**| Braidwood Units 1 and 2 – Responses to NRC Request for Additional Information (RAI) Regarding
Ultimate Heat Sink Temperature Increase License Amendment Request
(License Nos. NPF-72 and NPF-77)**

April 2015

Westinghouse Electric Company LLC
1000 Westinghouse Drive
Cranberry Township, PA 16066

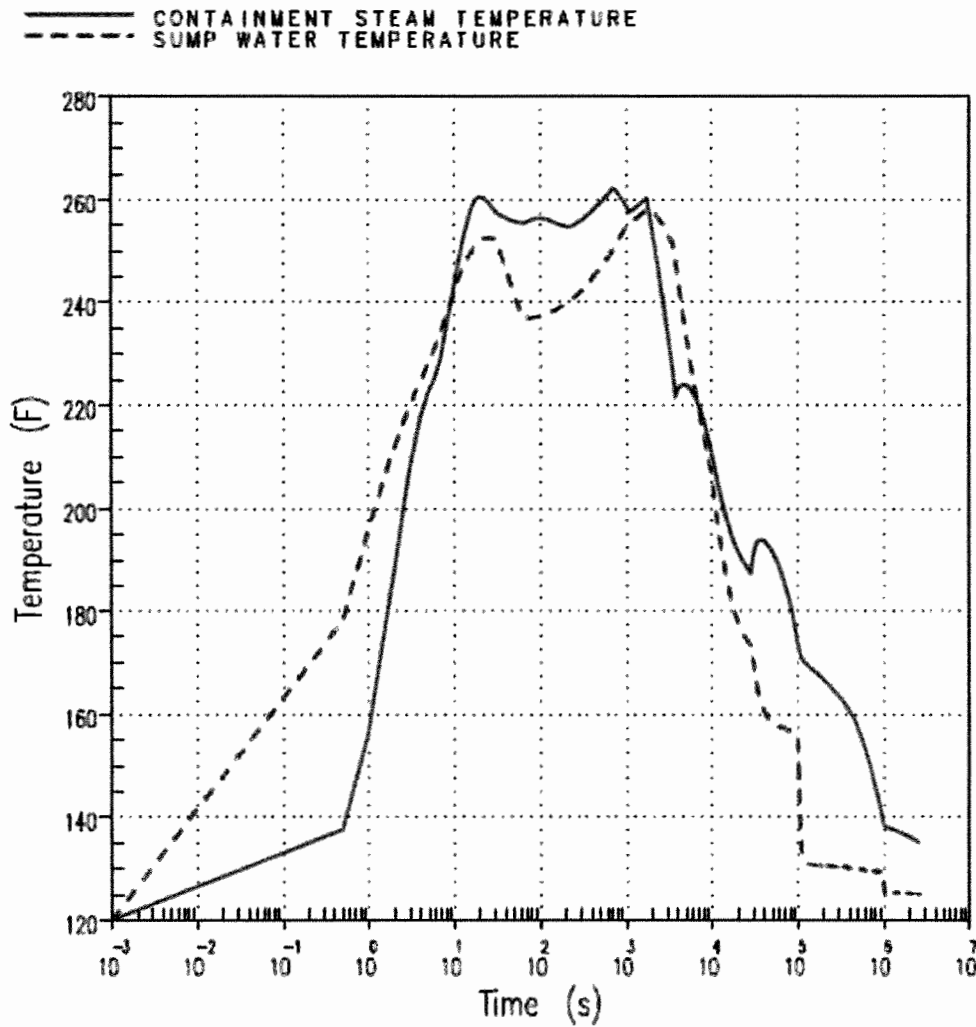
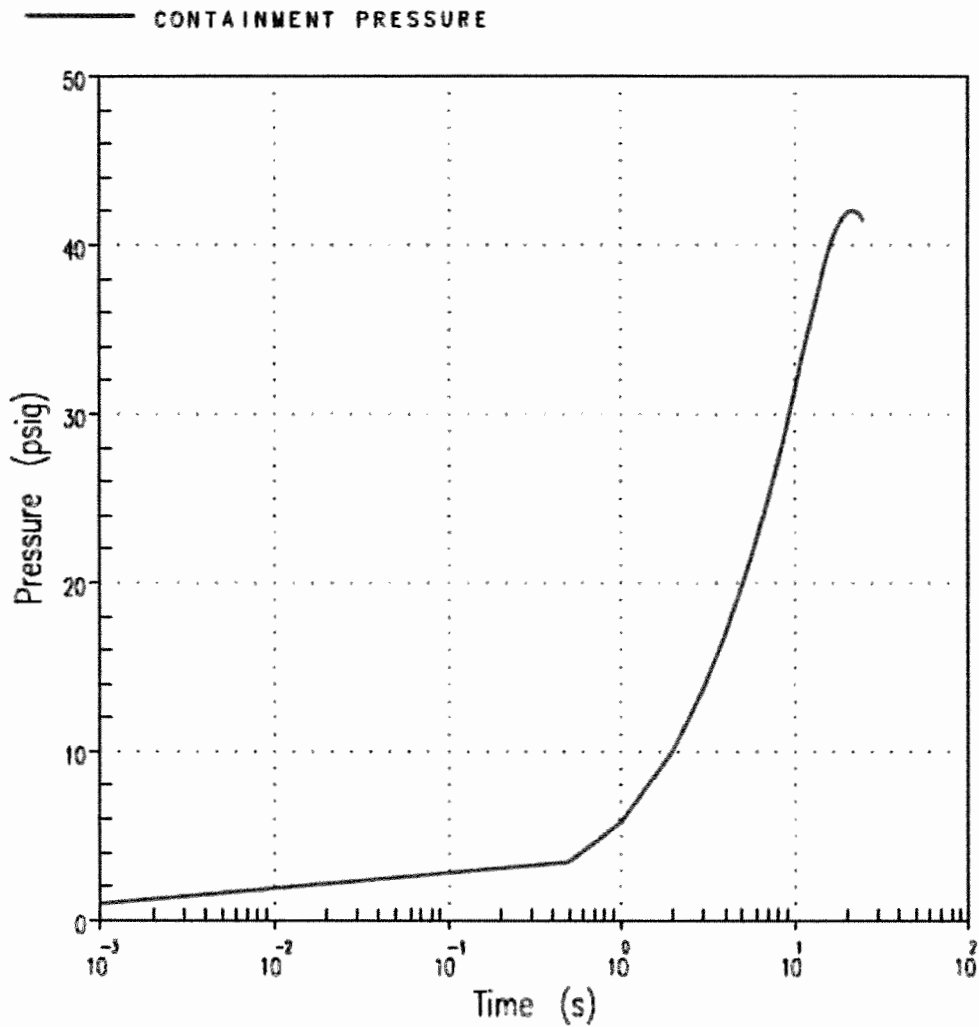
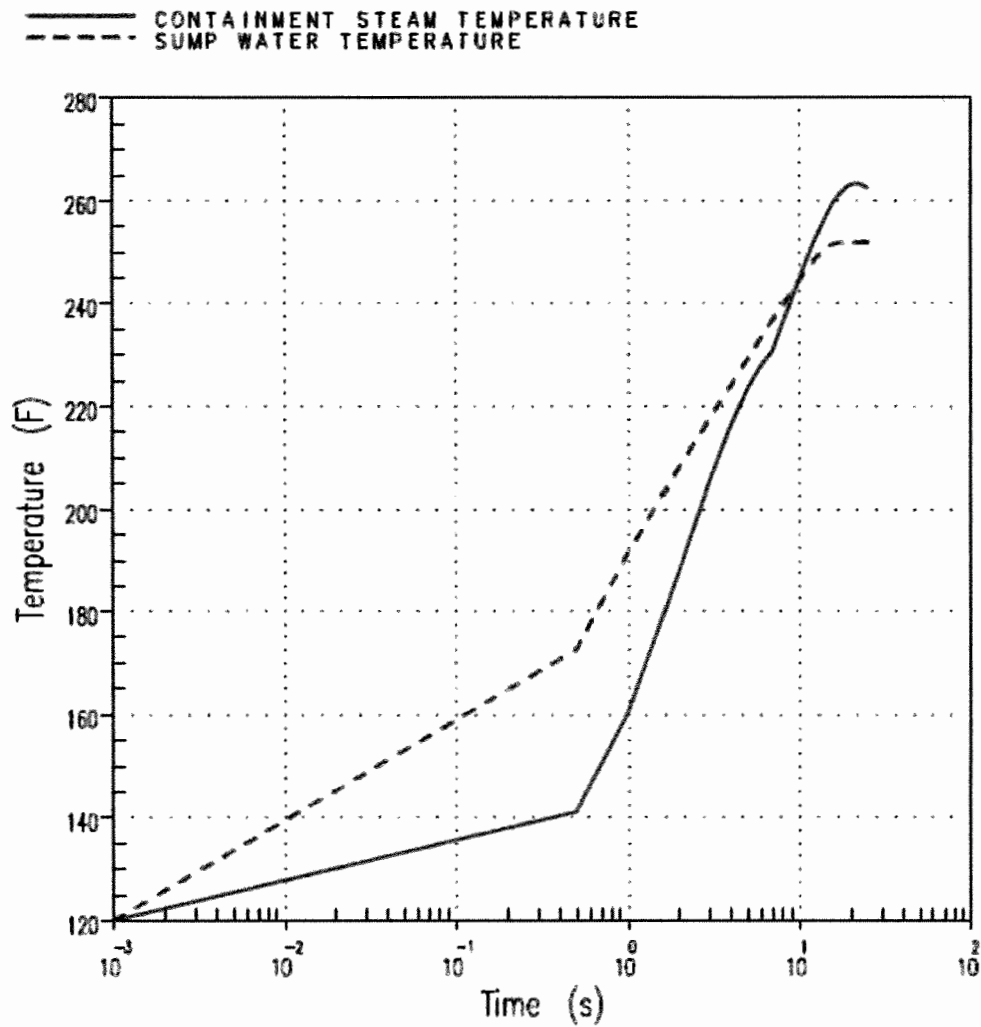
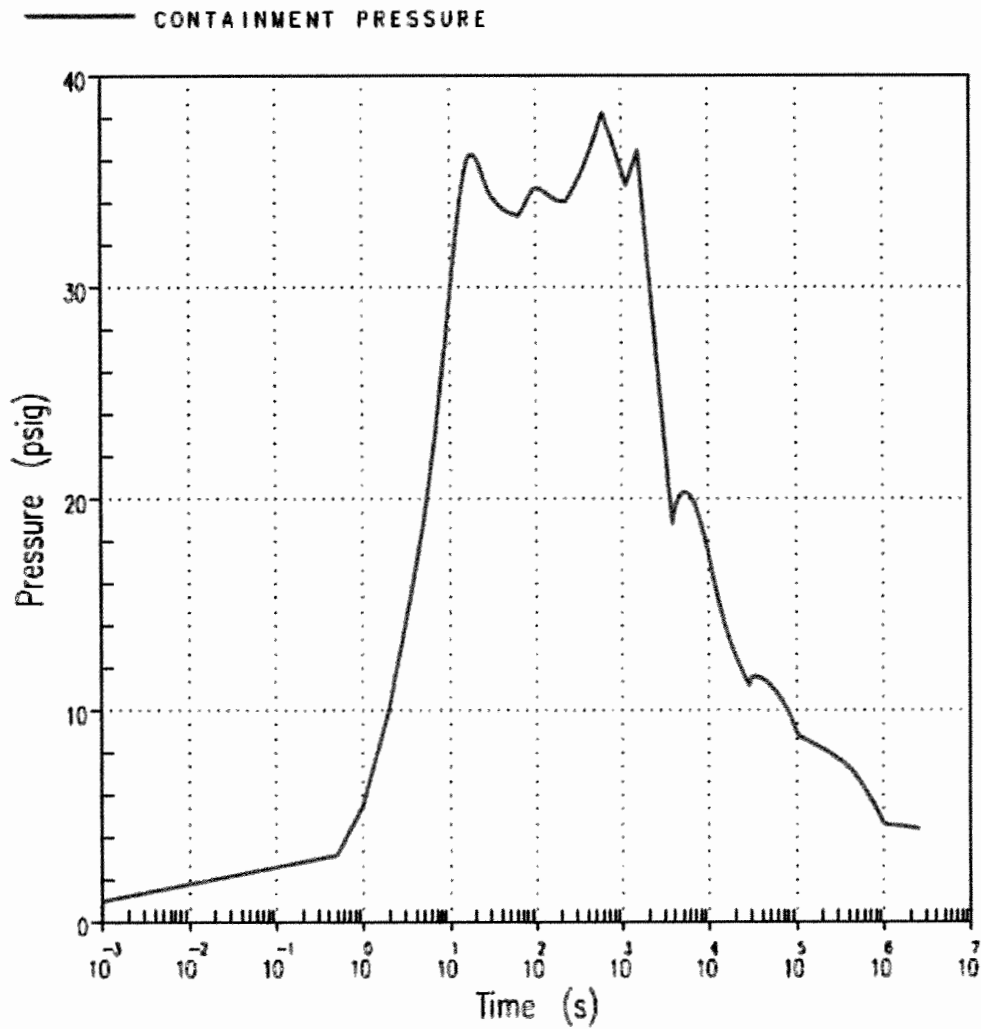
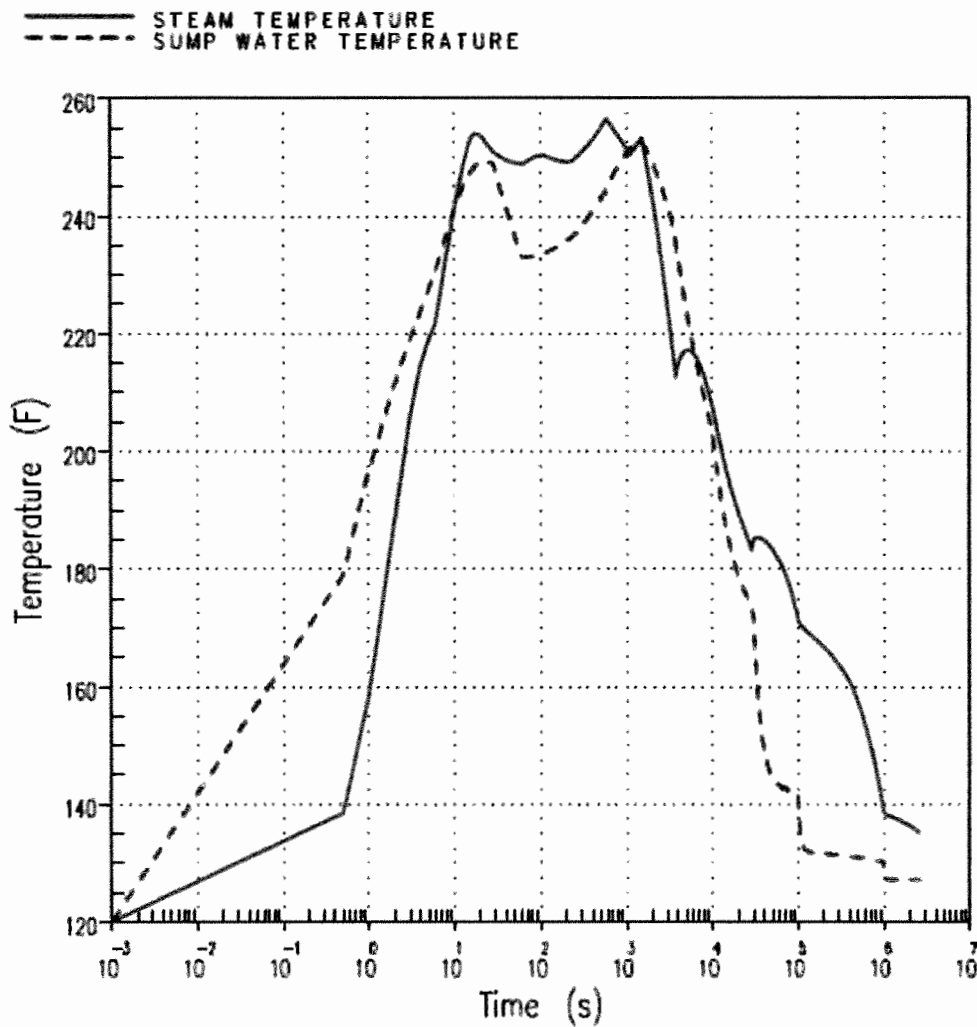
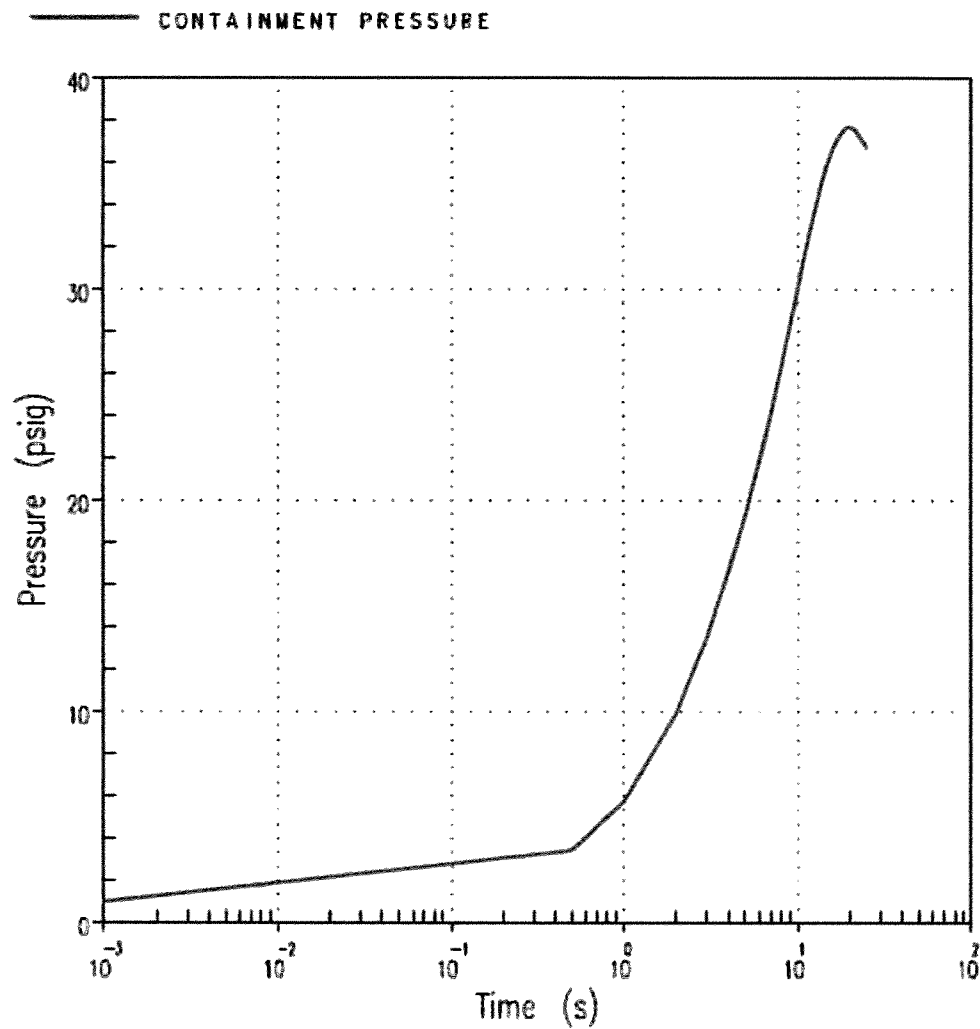
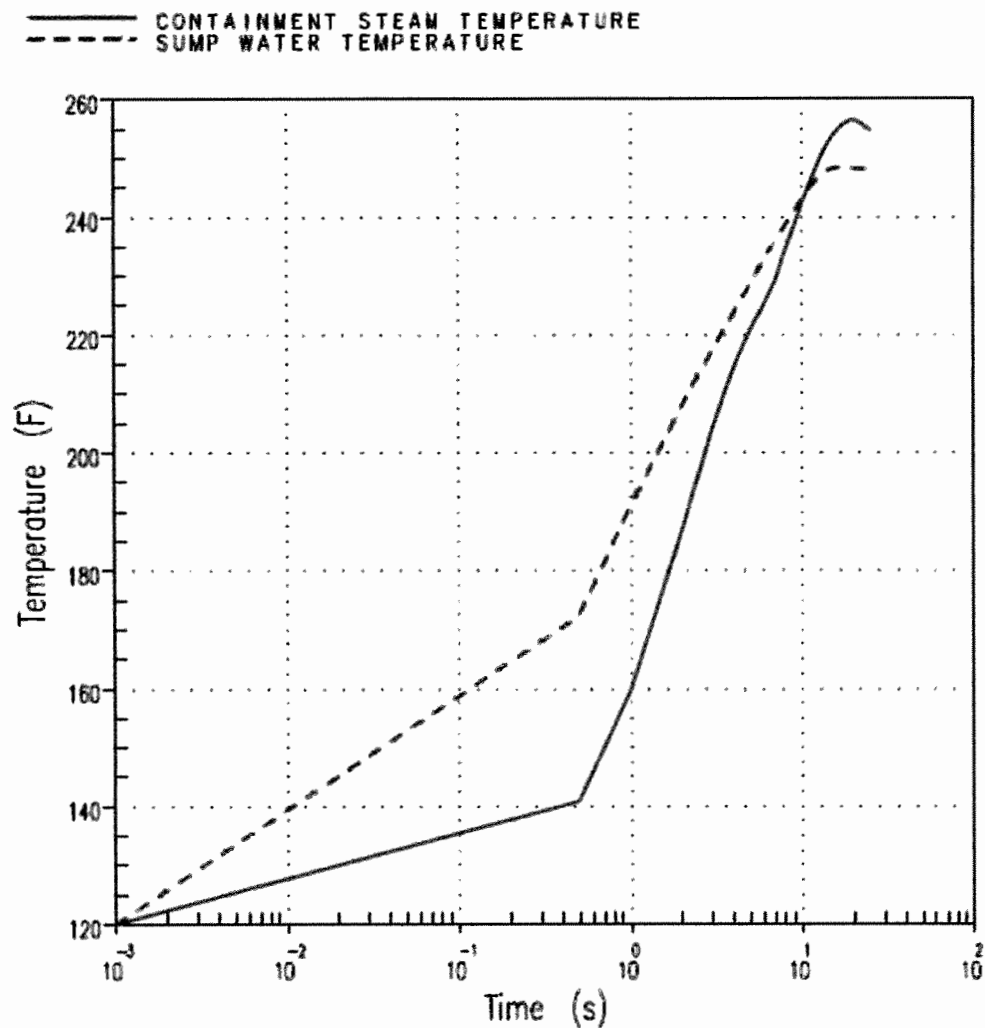
- (d) Provide the resulting graphs for the most limiting LOCA peak pressure analysis for the double ended hot leg break and double ended pump suction break for both units.*

Westinghouse Response – Item (d)

SCVB-RAI-6 – Figure 1: Units 1

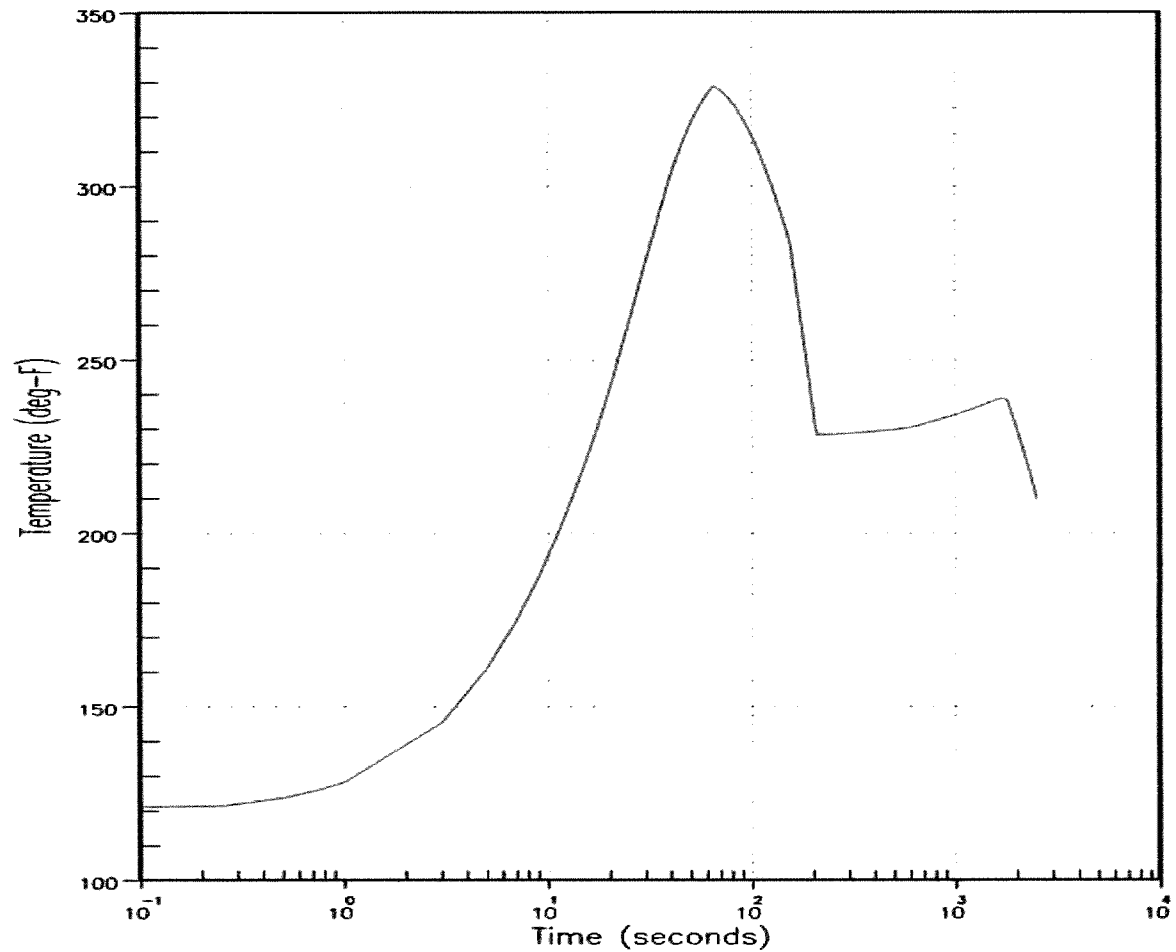
- (a) Describe the MSLB cases analyzed for containment peak temperature, and provide their comparison with the cases analyzed in the current analysis.*
- (b) If other than the currently analyzed cases were selected, provide basis for their selection.*
- (c) Provide a comparison of the inputs and assumptions in the proposed analysis that were changed from the current analysis. Provide justification for those inputs and assumptions in which the conservatism in the proposed analysis is reduced.*
- (d) Explain why the peak containment temperatures are less in the proposed analysis than in the current analysis.*
- (e) Provide the graph of the most limiting MSLB peak temperature profile case.*

Containment Temperature for SLB
Unit 1 Most Limiting SLB Case

SCVB-RAI-7 – Figure 1: Units 1

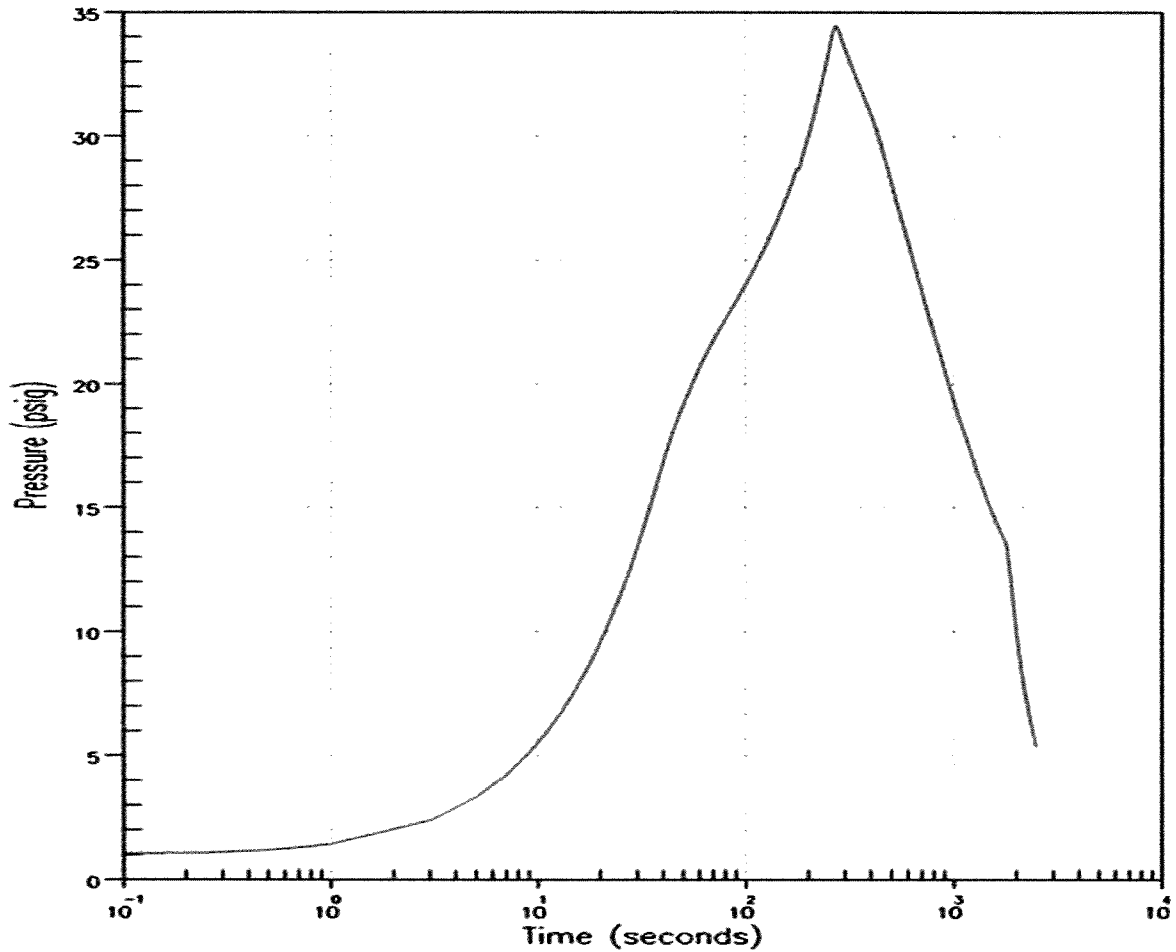
- (a) Describe the MSLB cases analyzed for containment peak pressure, and provide their comparison with the cases analyzed in the current analysis.*
- (b) Describe the cases in the proposed and the current analysis that resulted in the maximum peak pressures.*
- (c) If other than the currently analyzed cases were selected, provide basis for their selection.*
- (d) Provide a comparison of the inputs and assumptions in the proposed analysis that were changed from the current analysis. Provide justification for those inputs and assumptions in which the conservatism in the proposed analysis is reduced.*
- (e) Provide the graph of the most limiting MSLB peak pressure profile case.*

Westinghouse Response – SCVB-RAI-7 – Item (e)Containment Pressure for SLB
Unit 1 Most Limiting SLB Case
